Additional Information to Clause C56100

CONTROL PANEL ASSEMBLY FOR M130 DISPENSER SYSTEM

DISPENSER, GENERAL PURPOSE,
AIRCRAFT: M130

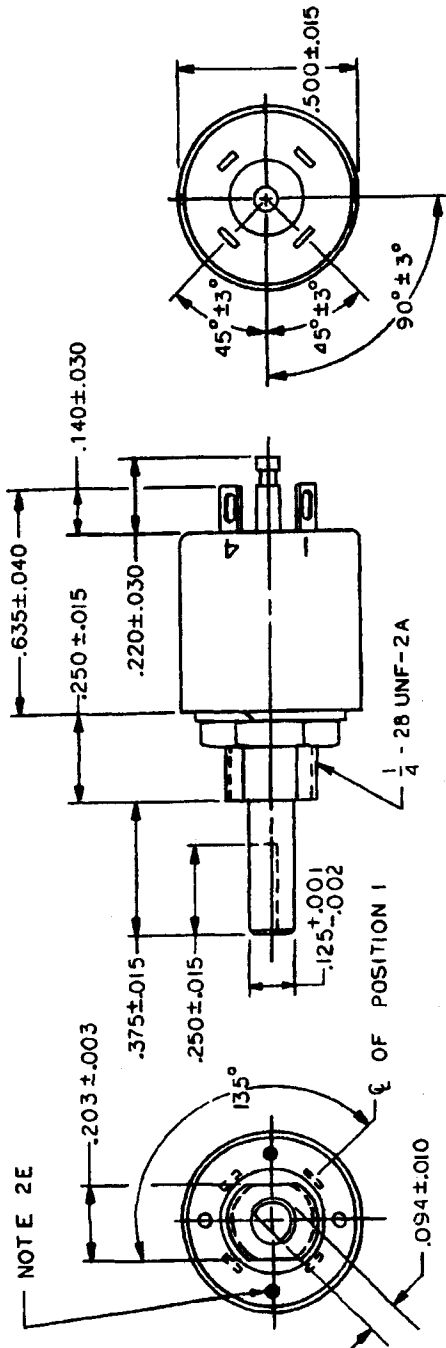
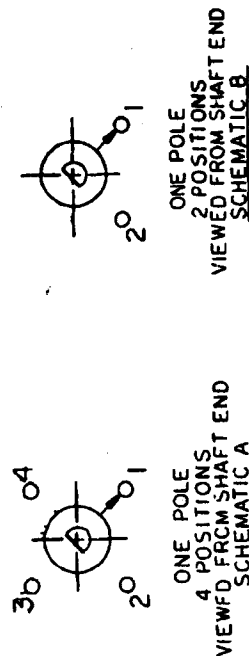
- DOCUMENT	DELETE	ADD OR REPLACE WITH
9280368	Sheet 2, REV B	Sheet 2, Rev C
9311488	Rev J	Rev K
9321253	BASE	
9321211	Rev C	Rev D
